**RFP #2022-02 Chiller Replacement - West Elementary School**

**ADDENDUM 2**

Project: NCPS, West Elementary School Chiller Replacement Project

Subject: Addendum #2 / Bid RFIs

TYPICAL PITCH POCKET

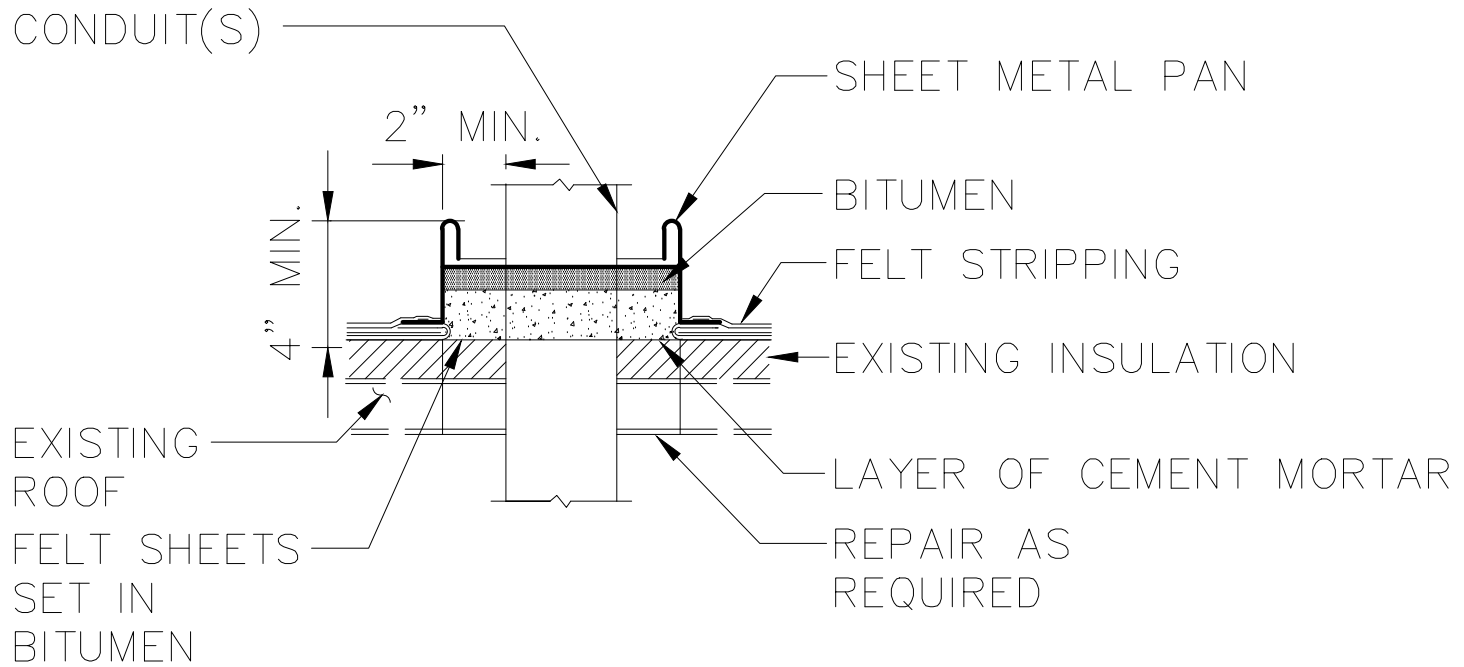
Q2: If we have to run new feeder up to the new unit, in lieu of reusing the existing conduit, please provide a detail for the roof construction.

*A2: Provide new roof penetrations as required and patch existing, compatible with existing roofing. Provide new leak proof penetration. See attached recommended detail.*
